ALIH						
ealth o	Check No.	34				
WAYLAND BOARD OF HEALTH LOCAL UPGRADE APPROVAL and/or VARIANCE REQUEST FORM						
Wayland	W					
hituate Road, Wayland, MA 01778

Alta at River's Edge; 484-490 Boston Post Road; Wayland, Massachusetts Board of Health Septic System & WWTF Regulation Variance Request

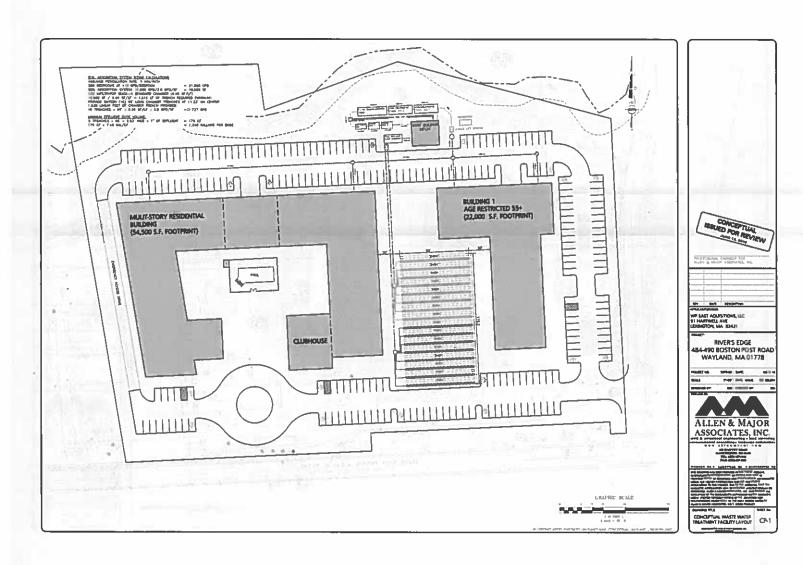
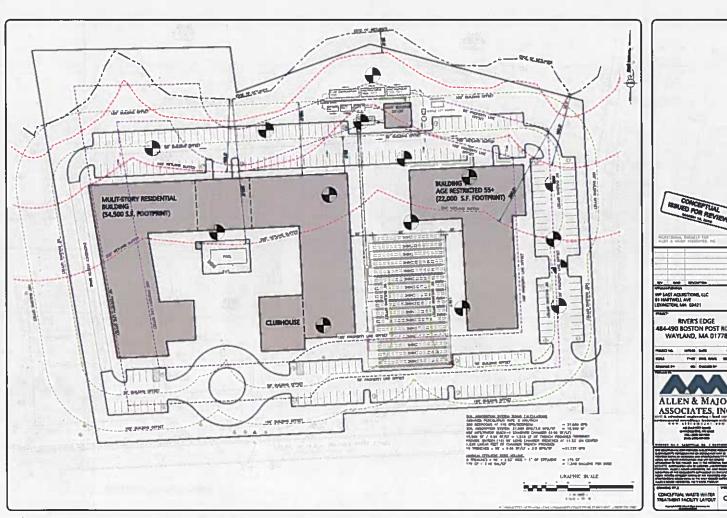
For the purposes of discussion, we have developed an attached figure, which shows the available area of the site (in yellow) that would be available for the wastewater treatment system and effluent disposal area while meeting the Town's setback requirements.

<u>Section 4.51 – Distances:</u> Similar to Section 4.40, the setbacks required in this Section cannot be met with the configuration approved by the Town in the RFP selection process. To assist the Board with review of this request, we've developed the following list of the setbacks that we are seeking relief from and prepared the attached figure, which shows the available area of the site (in yellow) that would be available for the wastewater treatment system and effluent disposal area.
